Text Amendment #2015-0003
Coordinated Development District Concept Plan #2015-0002
430 & 450 South Pickett Street – Cameron Park

Purpose of Application

1. A Text Amendment to modify the land uses within CDD 17A to include Home for the Elderly as a permitted use within the CDD.

Staff Recommendation: APPROVAL WITH CONDITIONS

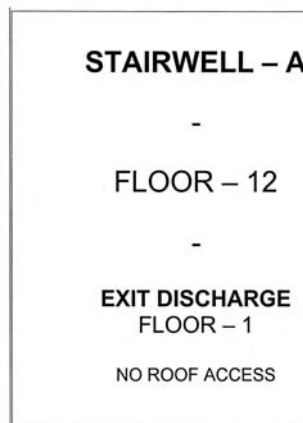
- Turning Radius – Wall to Wall = 54.98 feet + / - 2 feet
Curb to Curb = 51.33 feet + / - 2 feet
Inside turning radius = 37.73 feet + / - 2 feet
- Overall Length – 47' – 4 ½"
- Overall Width – 98"
- Wheel Bases from front axle to both rear axles – 240"
- Tandem axle spacing – 56" CL of axle to CL of axle
- Gross Weight – As built with no equipment or water gross weight = 66,000#
- Angle of Approach – 13 Degrees
- Angle of Departure – 11 degrees

- Ramp Break Over – Break over angle is 9°

Applicant has provided requested information. However, the turning radius demonstrated on the plans is too tight and will cause access problems for the fire department.

Figure 1020.1.6.2 Example Building Footprint Sign

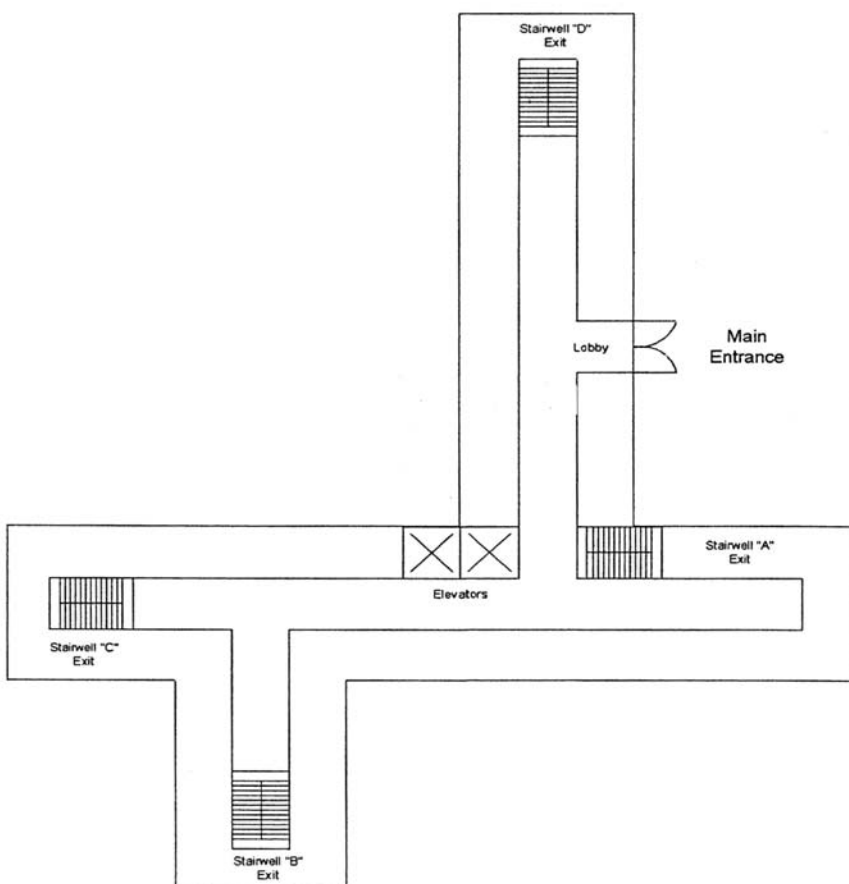
- C -10 Provide Stairway Identification. A sign shall be provided at each floor landing in interior vertical exit enclosures connecting more than three stories designating the floor level, the terminus of the top and bottom of the stair enclosure and the identification of the stair. The signage shall also state the story of, and the direction to the exit discharge and the availability of roof access from the stairway for the fire Department, in accordance with USBC 1020.1.6.

Footprint requirements. In buildings greater than three stories where there is no graphic representation of the building footprint, a simplified building schematic must be display in the lobby. The simplified building footprint shall be an overhead view of the buildings exterior and the general layout of the lobby of the first floor. Stairways shall be denoted by letter as stated in section 1020.1.6. (See Figure 1020.1.6.2)

Previously acknowledged by applicant.

Emergency Vehicle Easements

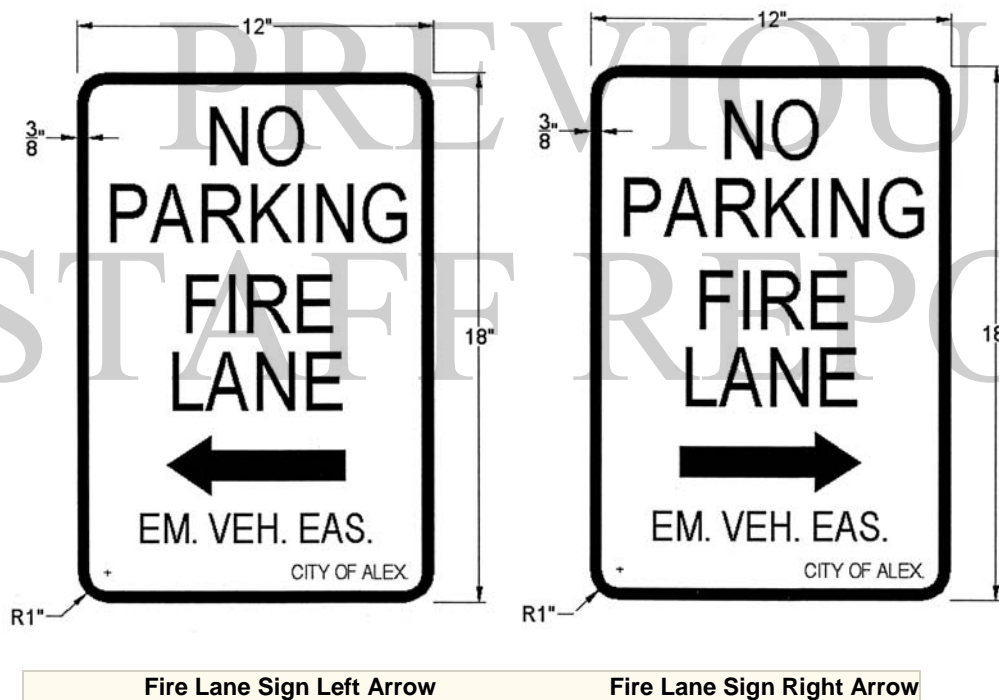
- C-8 The final site plans shall show placement of emergency vehicle easement signs. See sign detail and placement requirements below.

Emergency Vehicle Easements. Emergency vehicle easements shall be a minimum of 22 feet across the travel lane. The emergency vehicle easement shall provide access to strategic areas of the building and fire protection systems. Curbing and street components shall conform to the standards established by Transportation and Environmental Services and this document for emergency vehicle easements.

Tower 203 Turning Specifications

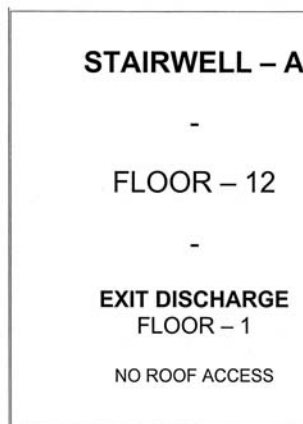
- Turning Radius – Wall to Wall = 54.98 feet + / - 2 feet
Curb to Curb = 51.33 feet + / - 2 feet
Inside turning radius = 37.73 feet + / - 2 feet
- Overall Length – 47' – 4 ½"
- Overall Width – 98"
- Wheel Bases from front axle to both rear axles – 240"
- Tandem axle spacing – 56" CL of axle to CL of axle
- Gross Weight – As built with no equipment or water gross weight = 66,000#
- Angle of Approach – 13 Degrees
- Angle of Departure – 11 degrees
- Ramp Break Over – Break over angle is 9°

Applicant has provided requested information. However, the turning radius demonstrated on the plans is too tight and will cause access problems for the fire department.

Figure 1020.1.6.2 Example Building Footprint Sign

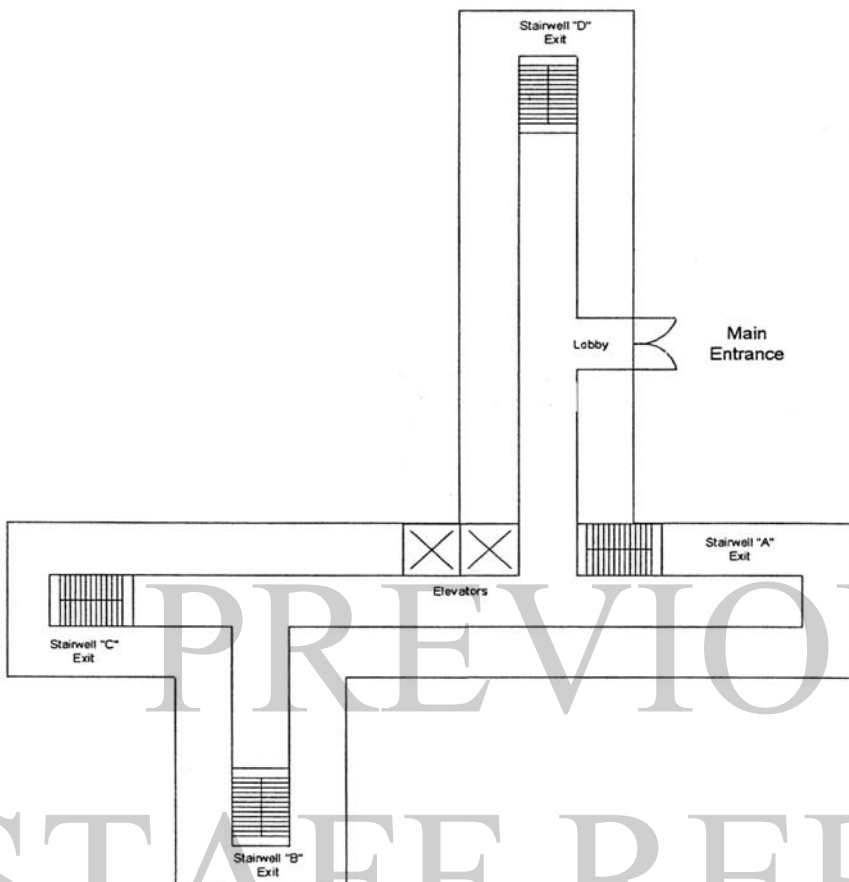
- C -10 Provide Stairway Identification. A sign shall be provided at each floor landing in interior vertical exit enclosures connecting more than three stories designating the floor level, the terminus of the top and bottom of the stair enclosure and the identification of the stair. The signage shall also state the story of, and the direction to the exit discharge and the availability of roof access from the stairway for the fire Department, in accordance with USBC 1020.1.6.

Footprint requirements. In buildings greater than three stories where there is no graphic representation of the building footprint, a simplified building schematic must be display in the lobby. The simplified building footprint shall be an overhead view of the buildings exterior and the general layout of the lobby of the first floor. Stairways shall be denoted by letter as stated in section 1020.1.6. (See Figure 1020.1.6.2)

Previously acknowledged by applicant.
